**Addendum**

Reconstruction to  
Cornwall-On-Hudson Elementary School  
Cornwall Elementary School  
Cornwall Central Middle School

Tt Project No. 363579-22001.3 – Phase 3

BID Addendum No. 5  
to  
Drawings and Project Manual  
September 30, 2024

**AC02B**

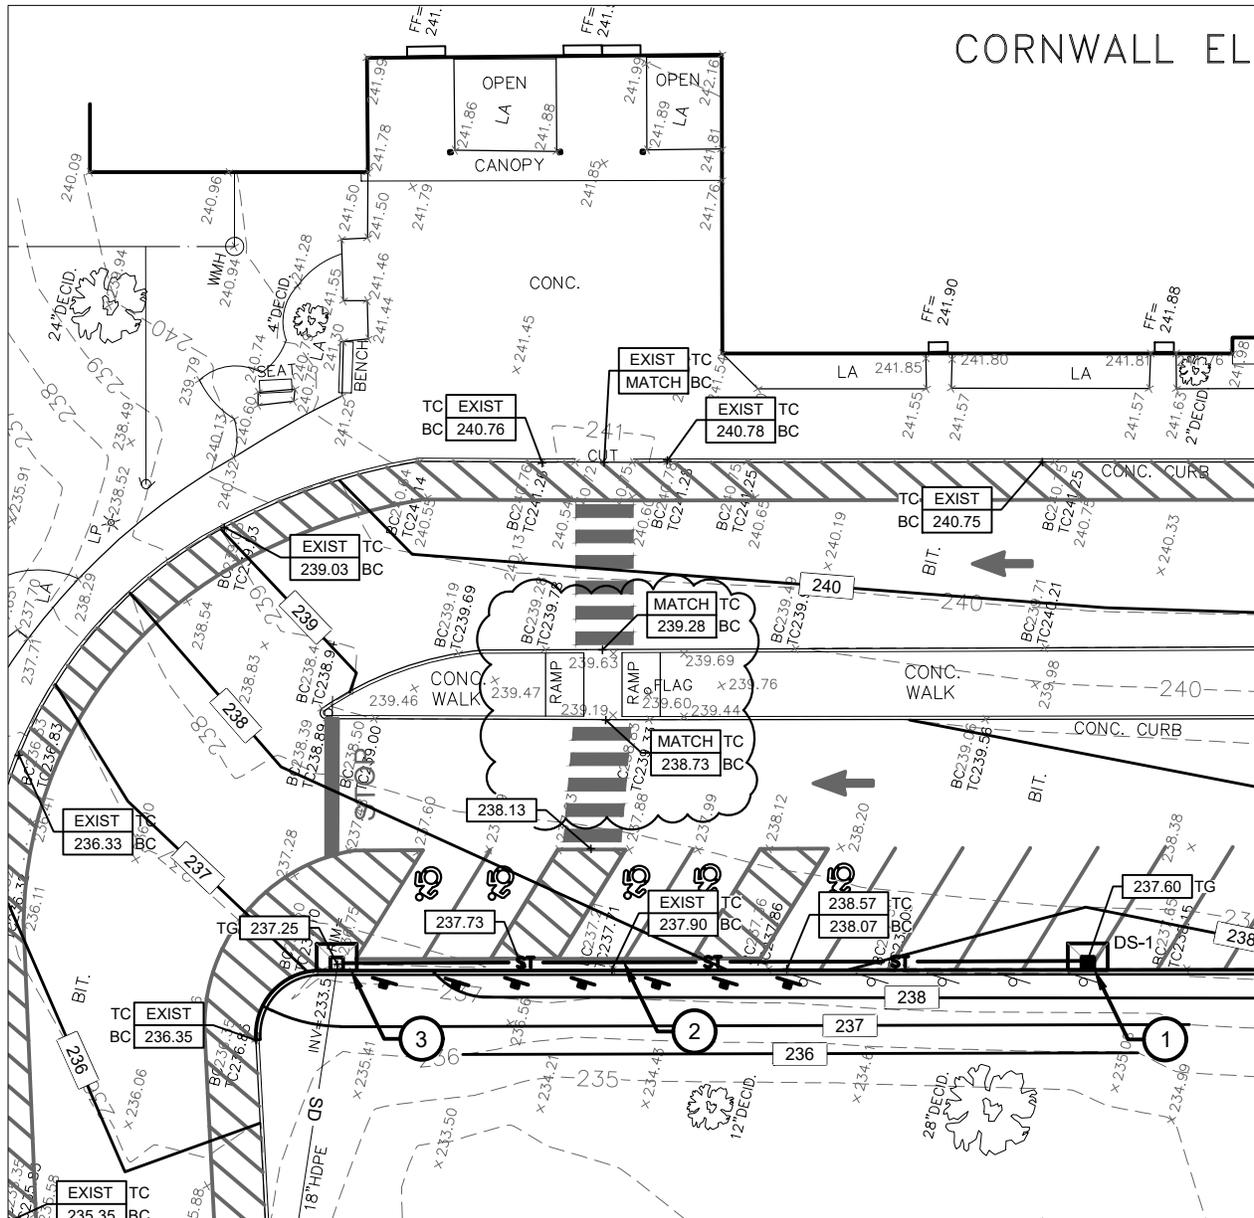
ITEM 5-C-7: Refer to DRAWING AC120

1. Site Layout Keynote 6, (hexagon), AMEND to read as follows:  
“6. NOT USED.”
2. Detail 1, AMEND as shown on Drawing AC02B attached to this addendum.

**AC03B**

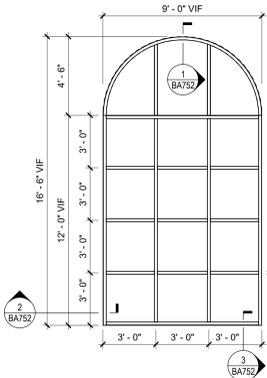
ITEM 5-C-8: Refer to DRAWING AC130

1. Detail 1, AMEND as shown on Drawing AC03B attached to this addendum.
